Newport City Council – Planning Consultation

Application Number: 26/0425

Site: Land To The Rear Of The Kings Arms Belmont Hill, Caerleon

Proposal: CONSTRUCTION OF RETAINING WALLS TO FACILITATE THE CREATION OF A KITCHEN GARDEN AND ORCHARD TO PROVIDE ORGANIC FOOD FOR THE ASSOCIATED RESTAURANT (PART RETROSPECTIVE)

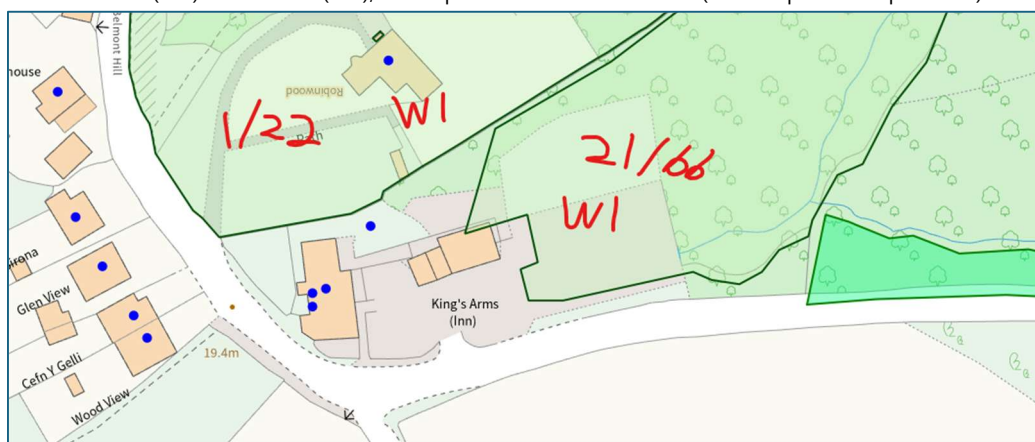
The proposed retaining wall abuts the wooded bank which has protected trees growing on it (Tree Preservation Order 1/22 (W1), which can be seen in the Google Image below. Therefore the following report is required in order to assess the impact of the retaining wall upon the trees:-

Tree Survey and Tree Constraints Plan (TCP)

In accordance with BS5837 Trees in relation to design, demolition and construction – Recommendations (2012), a **Tree Survey and Tree Constraints Plan** must be submitted with the application, to include all trees, shrubs or hedges on the bank, within 15m of the proposed retaining wall (i.e. within potential influencing distance).

The tree survey must clearly show crown spreads and Root Protection Areas, which must then be considered as a constraint to development.

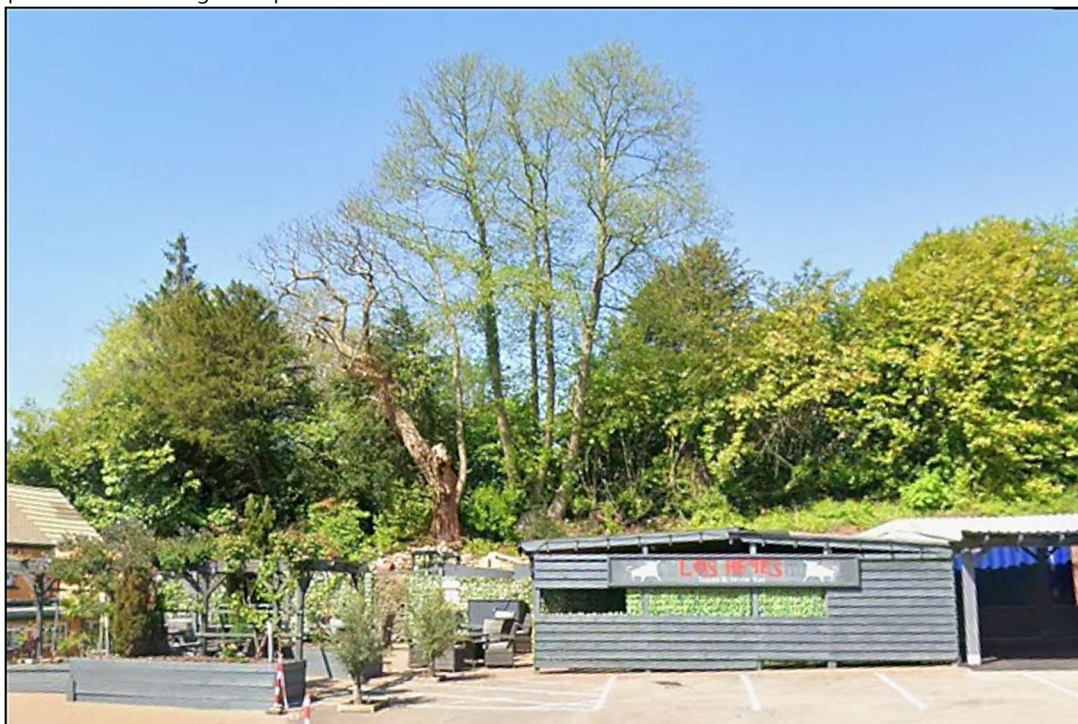
It is noted that the trees adjoining the site are afforded protection under two Tree Preservation Orders:-

Reference: 21 of 1966 (W1) and 1 of 22 (W1), which protects both woodlands (refer to plan excerpt below).
